394 Robertson Rd, Cardup (PA23/198), Environmental Noise Assessment – Peer Review

We have undertaken an acoustic review and appraisal of the following reports
Environmental Noise Assessment – Lot 60 Norman Road, Cardup by Lloyd George Acoustics,
dated 14/07/23, Ref: 22107634-01A [LGA1]

Figure 2 - Metropolitan Regional Scheme land zoning Map (Similar to Shire of S-J draft LPS 3)

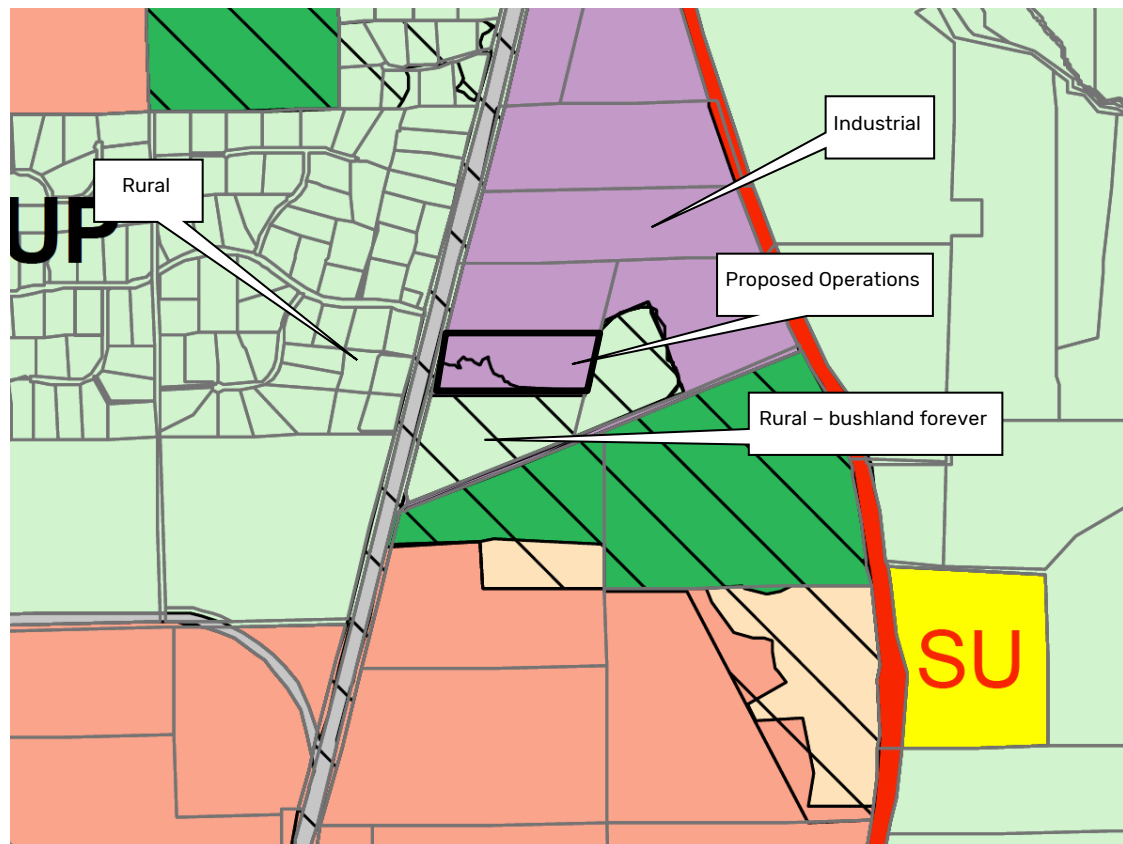
As the land to the north of Permacast is zoned industrial, it is likely that industrial neighbours will occupy this land. Example areas are shown in Figure 1 above.

Due to these industrial neighbours, no individual industrial operator would be allowed to *significantly contribute*⁶ to industrial noises at the nearest residences. This means that each industrial operation, including the Permacast operations must emit a noise no greater than 5 dB below the Assigned Level.

To prevent significant noise contribution at the nearby residences, each industrial neighbour has a revised noise emission criterion of:

$$L_{A10} \ 36-5 = 31 \text{ dB before 7am and}$$

$$L_{A10} \ 46-5 = 41 \text{ dB after 7am.}$$

These criteria are 7 dB lower than the Assigned Level criteria used by LGA and referenced in Table 1 above.
